SEPTEMBER 16, 2022

ADDENDUM NO. 02 to the plans and specifications for the MACOMB COUNTY JAIL, VARIOUS PROJECTS PROPOSAL A, B AND C, MT. CLEMENS, MI, Architect's Project No. 221958, dated August 26, 2022

**PROPOSAL A-SANITARY REPLACEMENT**

**PROPOSAL B-BARRIER MESH/SCREEN**

**SIXTH FLOOR PLAN**  
SCALE: 1/32"=1'-0"  
**17,304 S.F.**

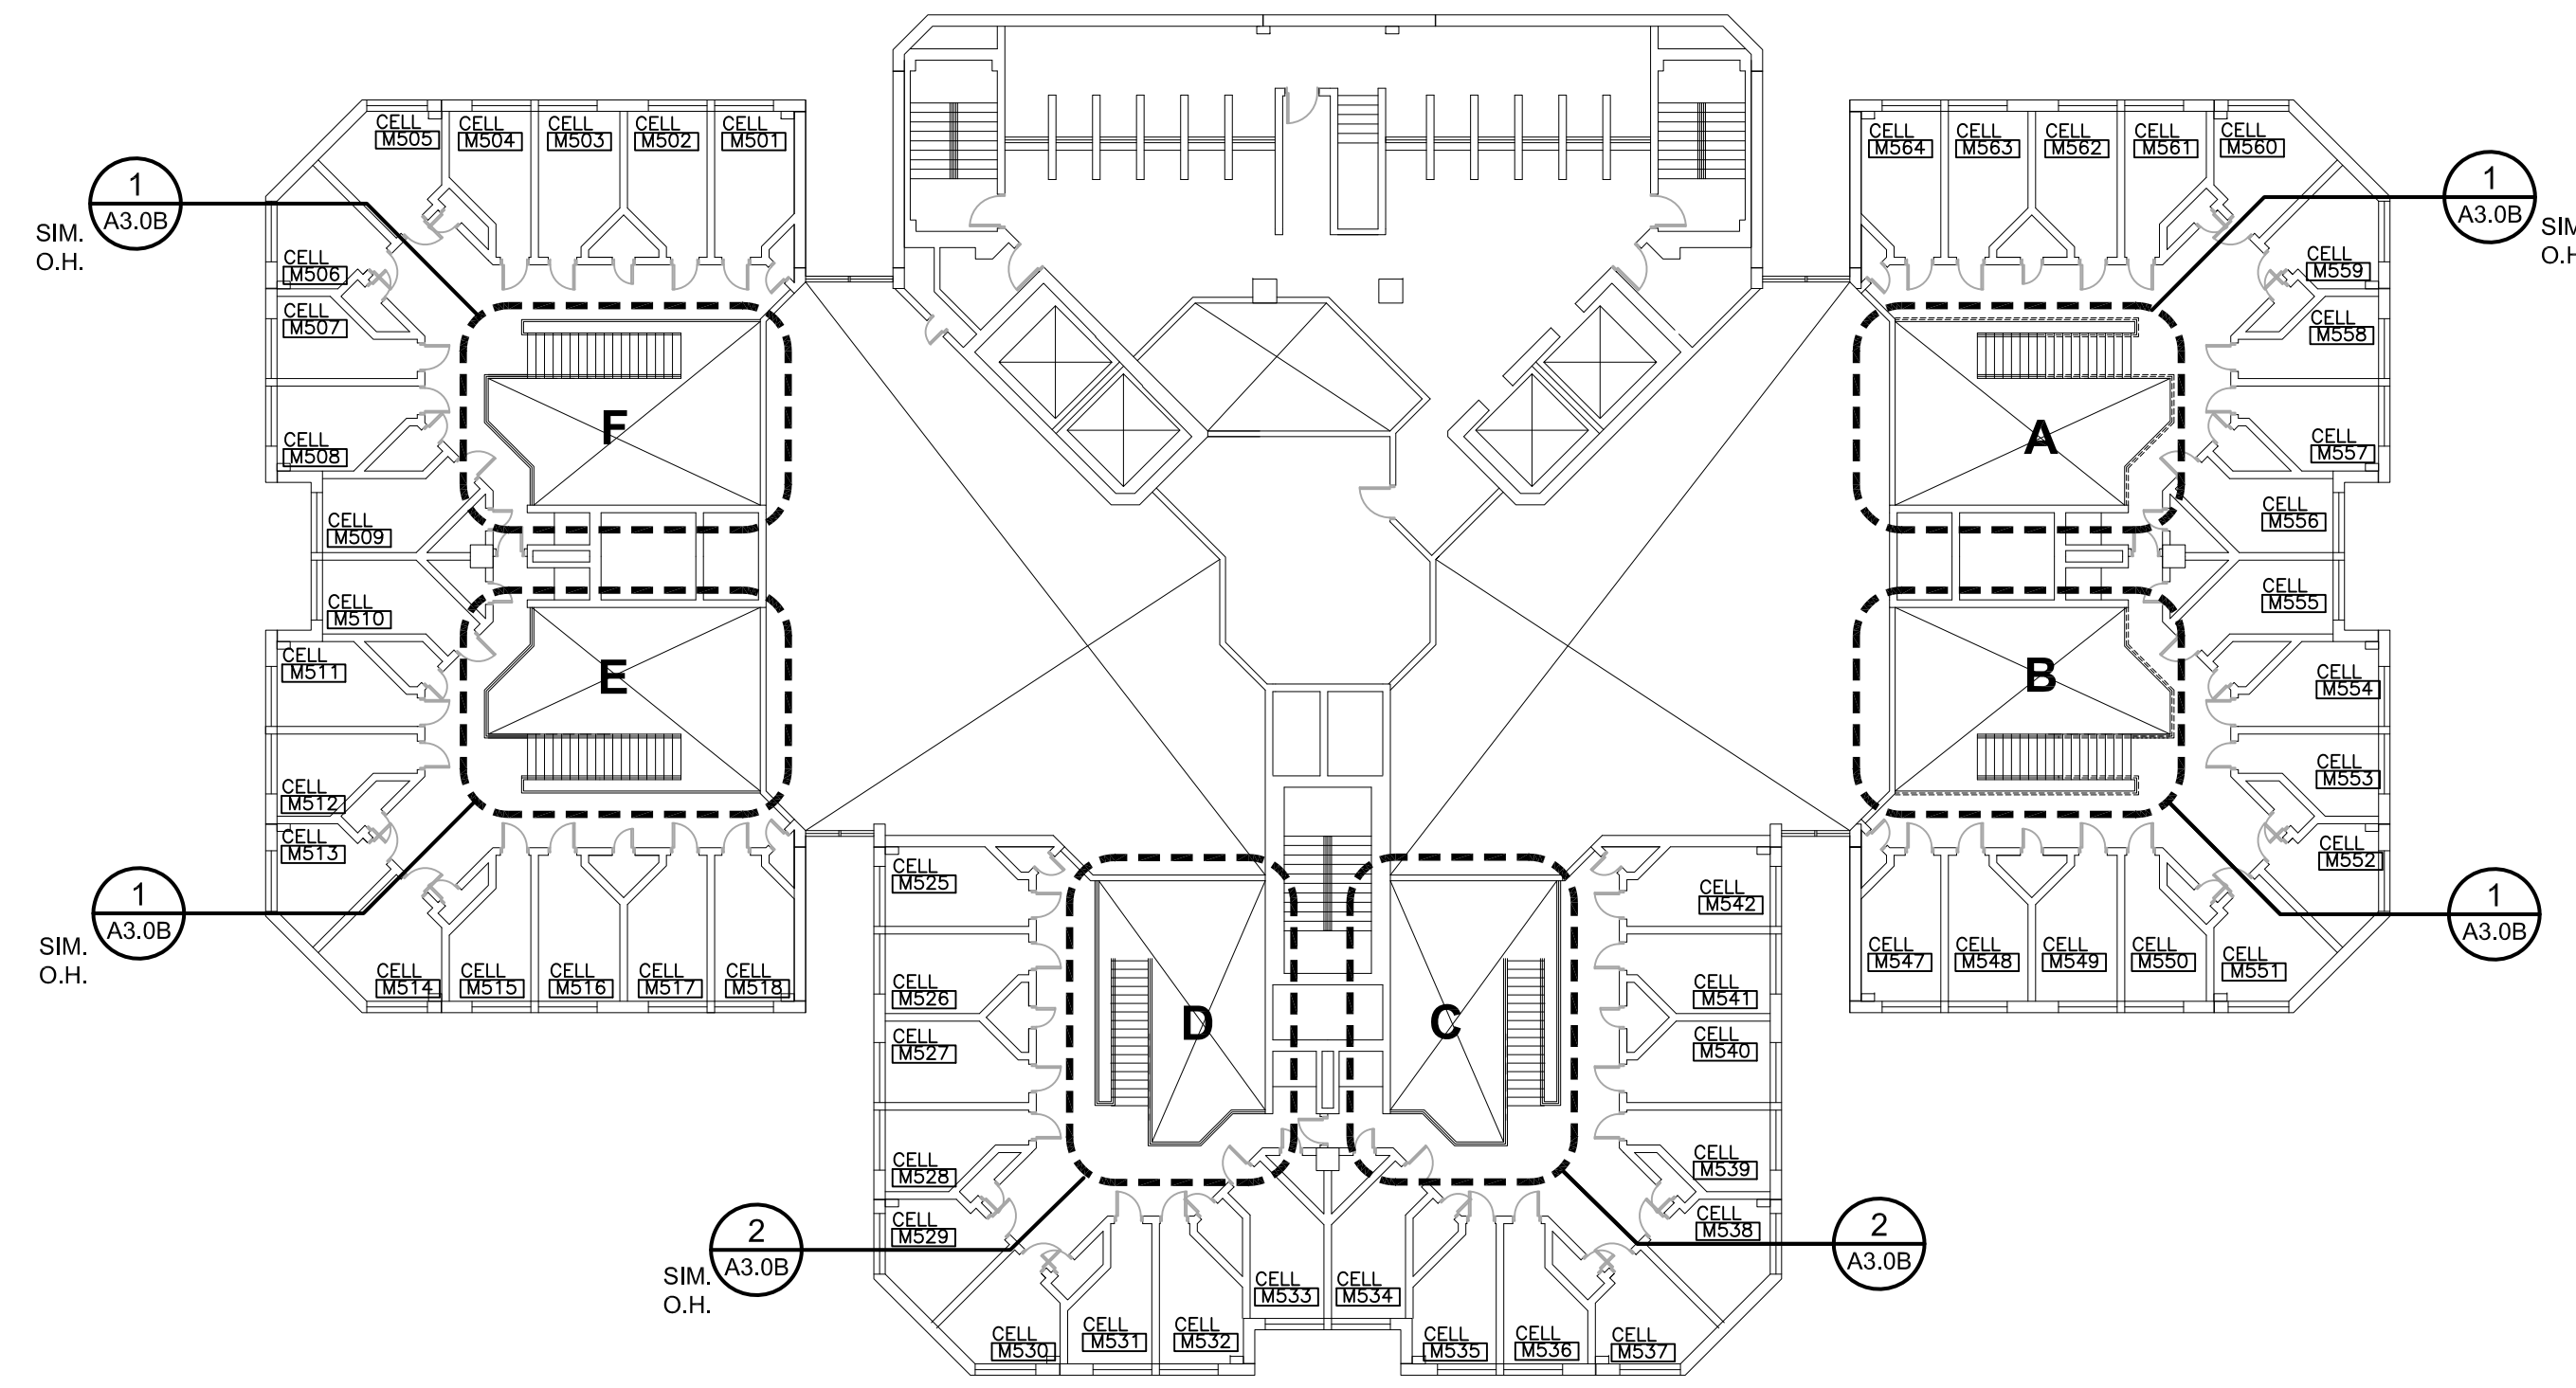
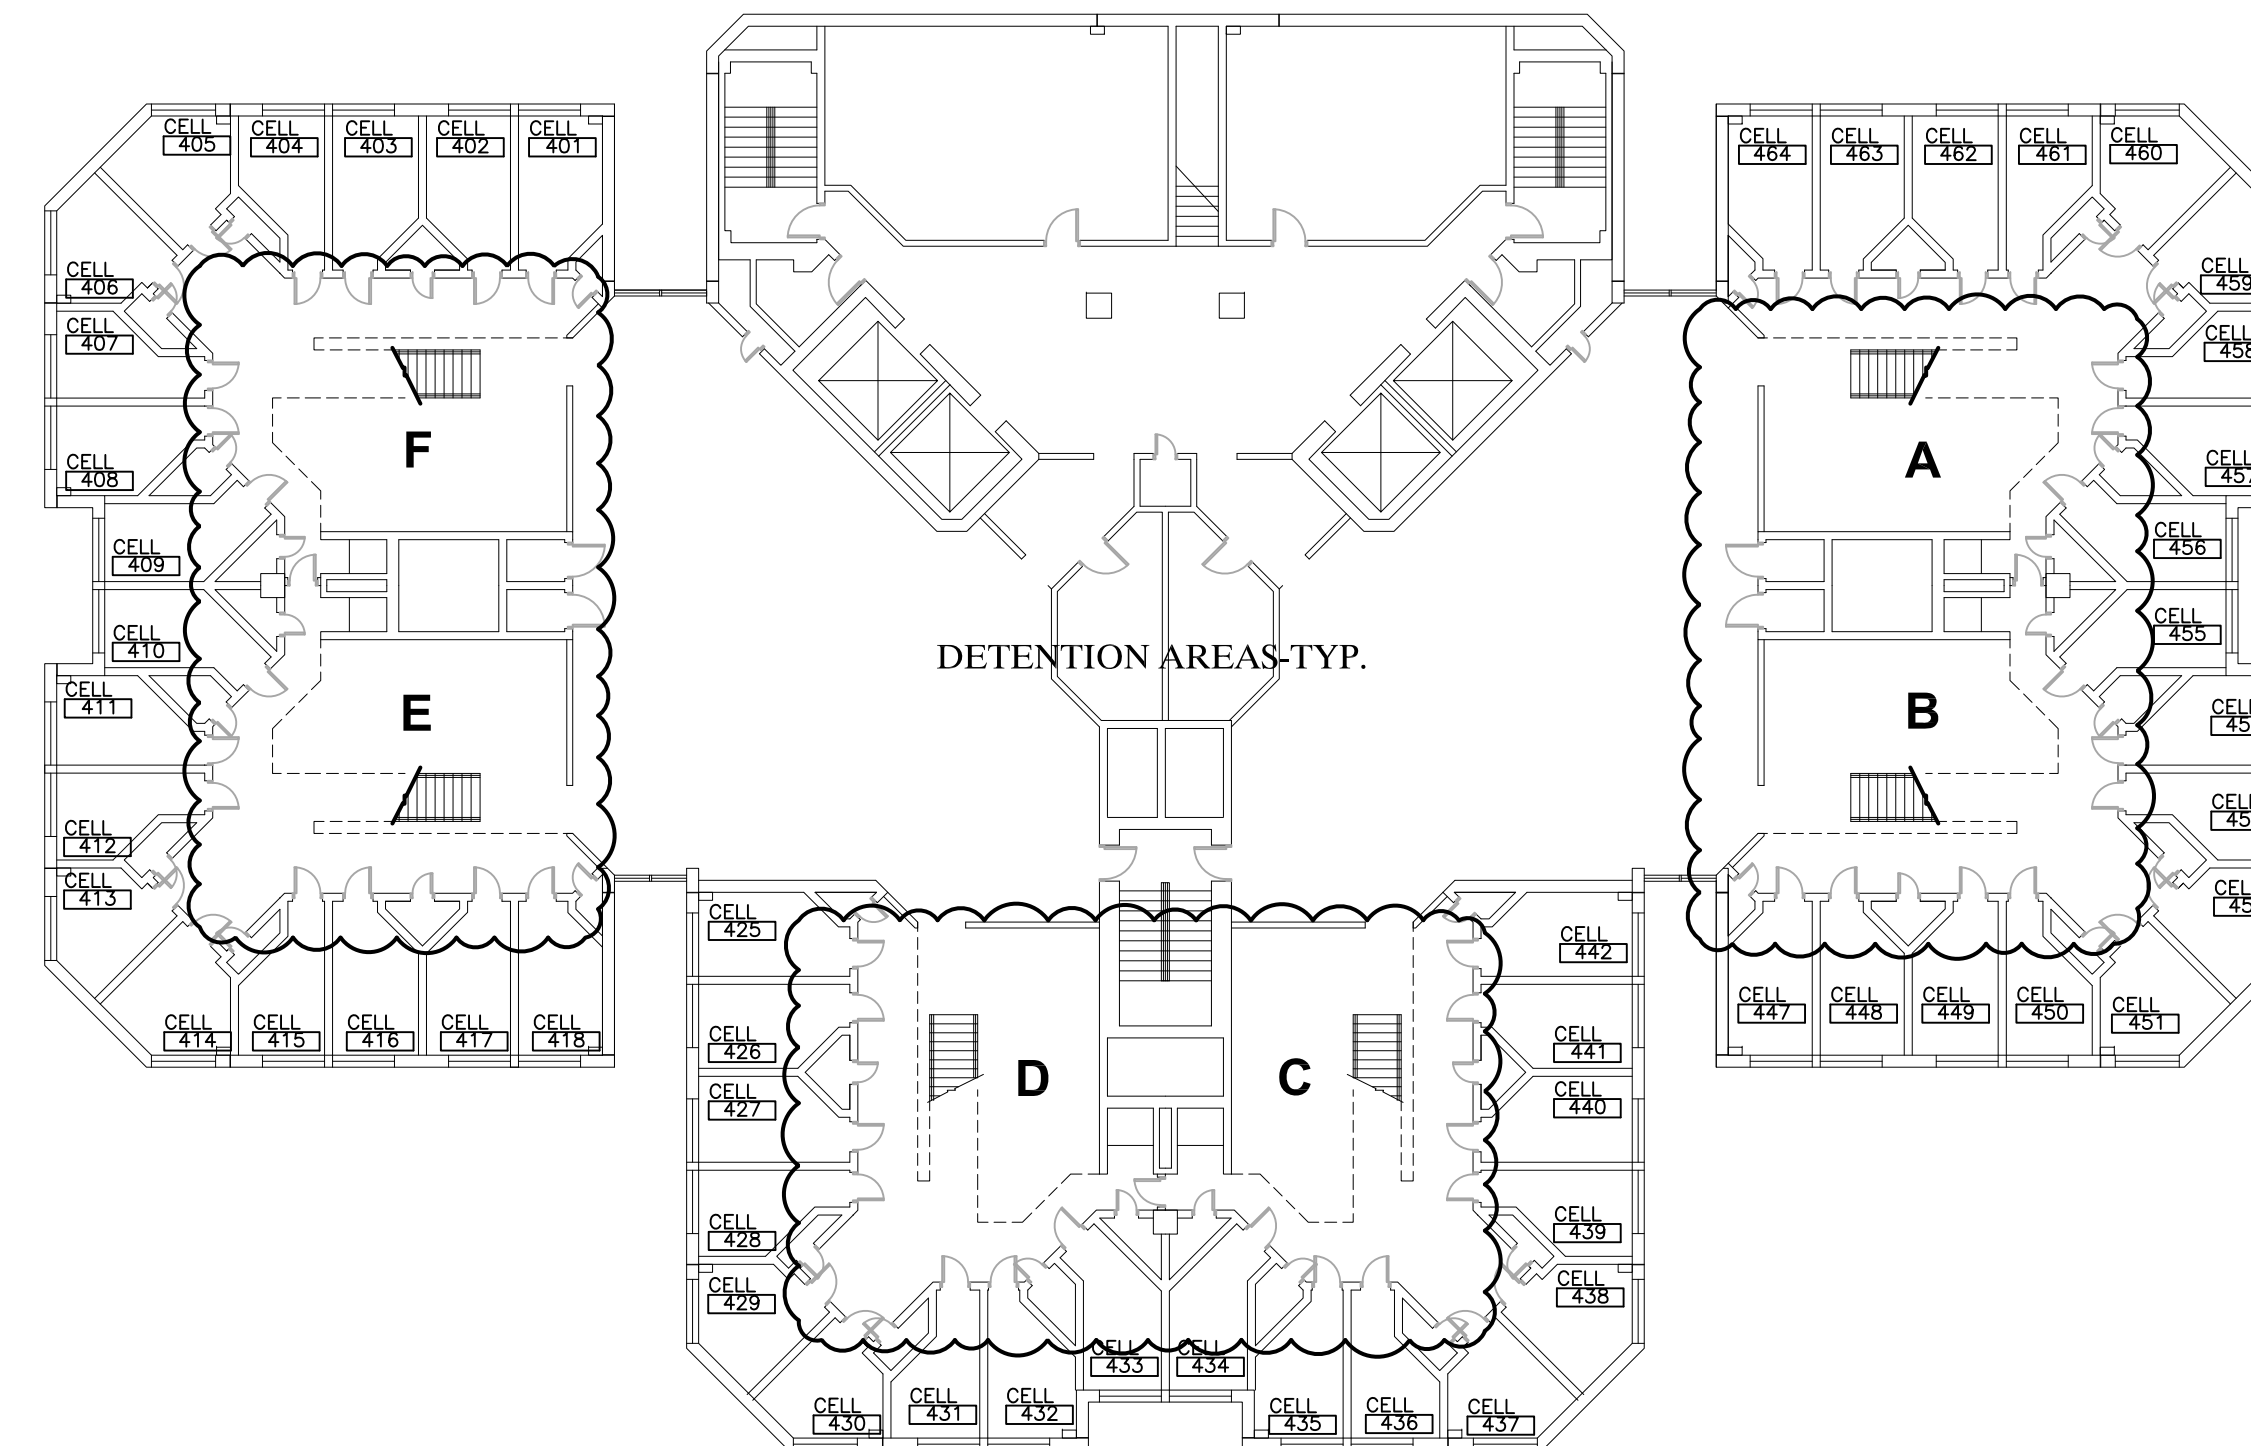
- ITEM NO. A3:** Refer to sheet A03.A(re-issued):
1. Removed callout 1 and 2 from floor plans 4 and 6.
